MXR204A-01

Modification Available Performance Enhancement Service Note

MXR204A – Infiniium MXR-Series Real-Time Oscilloscope, 2GHz, 16GSa/s, 4 Ch

This is the power supply with fan (0950-6306):

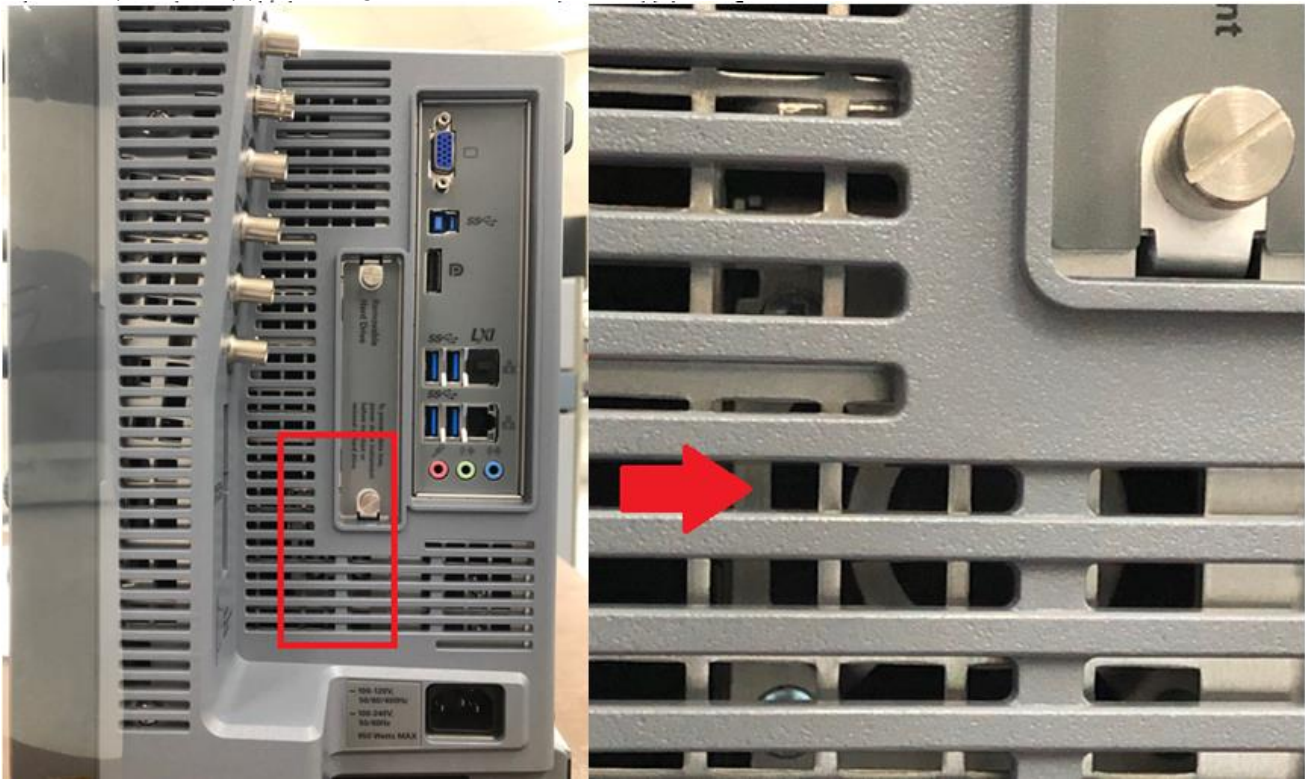
Fans located in the power supply make the oscilloscope noisy.

Install the 0950-6466 Fanless Power Supply following the instructions in the Service Guide.

This is how you can find out if the old power supply with noisy fans is in. You will be able to see small fan from power supply through ventilation hole:

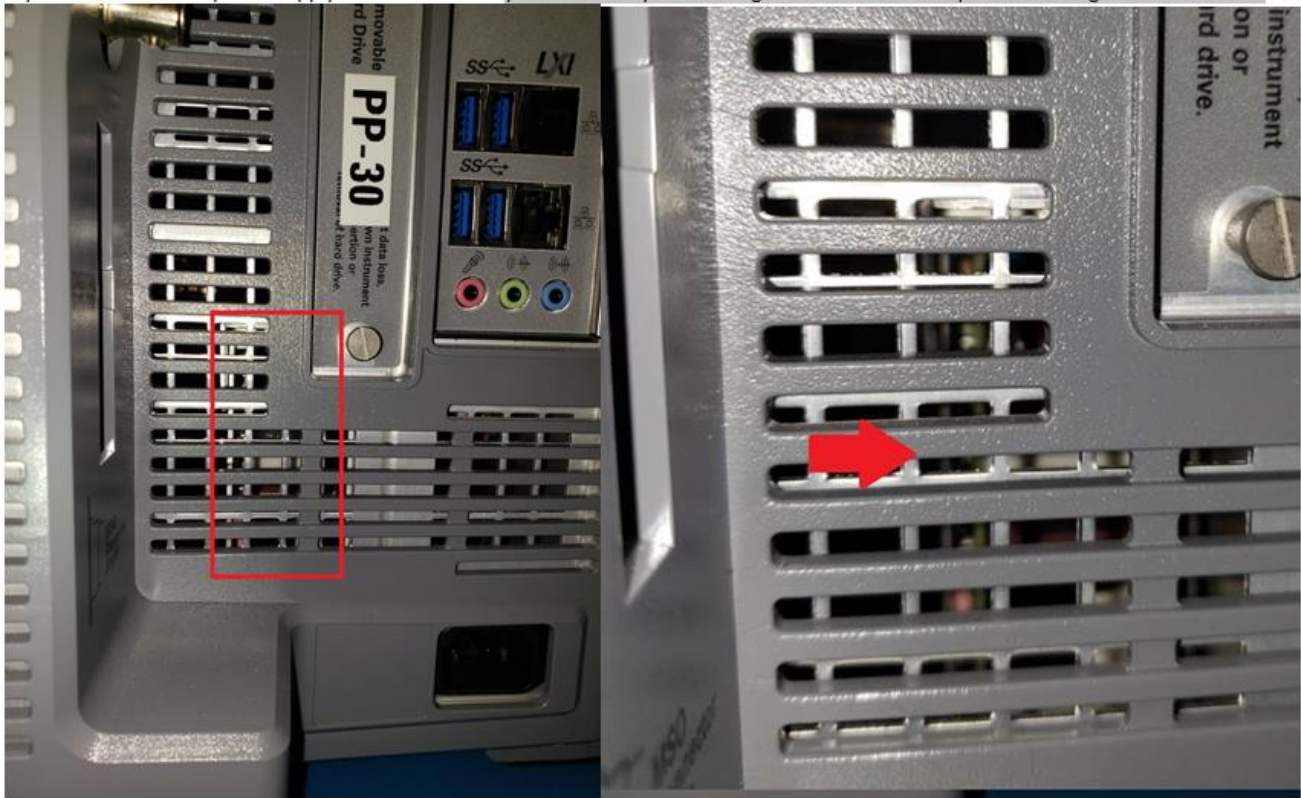
This is how the new fanless power supply will look like. You can see the edge of the PCA and components through ventilation hole.:
